EL'S NAME Stl T.S. MOCAMBIQUE Rpt. Drillings, No. ✓

of Survey 2nd. S.S. No. 3. Classification

Steel Twin Sc. "MOCAMBIQUE"

THICKNESSES OF PLATING ascertained by drilling, and comparison of same with the original thicknesses.
DECIMALS

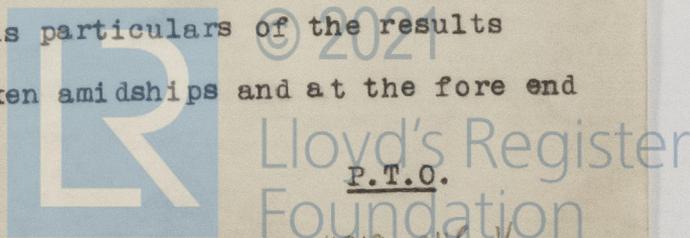
Plates marked — are individual plates in way of the waterline.

The Lisbon Surveyor now forwards particulars of the results of the drilling of the shell plating taken amidships and at the fore end as shewn above.

It is submitted the plating be approved provided all plates below the sheerstrake within the half length amidships on port and starboard sides worn to below 17/40" and all plates at the extreme ends worn to below 14/40" be renewed and the shell plating at the after end drilled and found satisfactory.
